Accessibility Survey

City of Downey Cleta Street - Lakewood Boulevard To Downey Avenue

Date of Inspection
12/9/2016

Disability Access Consultants

Change In Level East Of Patton Road @ 33.932384879948, -118.130525350571

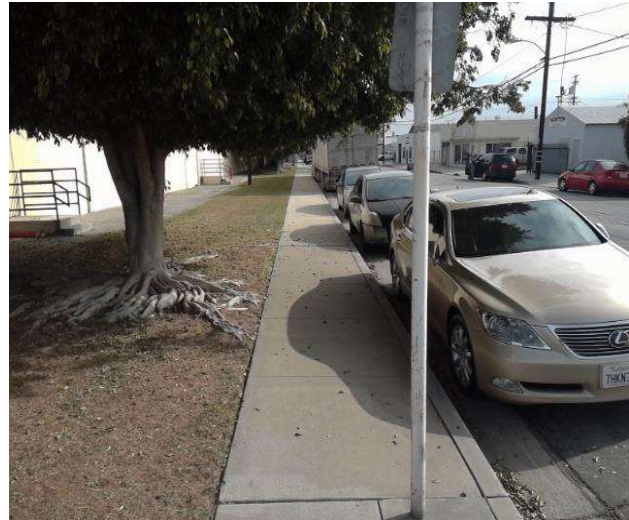
Sidewalks , Change in Level : Change in Level Non Beveled

There is a change in elevation greater than recommended value.

On-Site Finding 0.50 inches

Ensure that the change in elevation is within the recommended value.

Recommendation Up to 0.25 inches

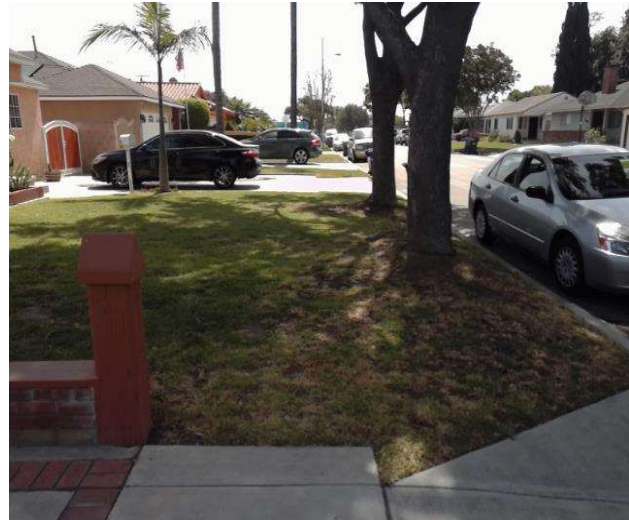
Section of sidewalk is missing and consists of dirt, grass or gravel.

On-Site Finding 116.00 feet

Provide a compliant sidewalk for the missing section.

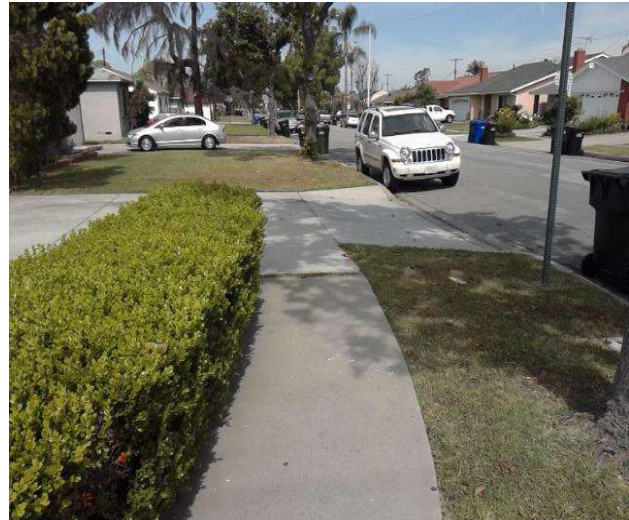
Sidewalk width at the obstruction is not compliant.

On-Site Finding 43.00 inches

Sidewalk width at the obstruction shall have the recommended value.
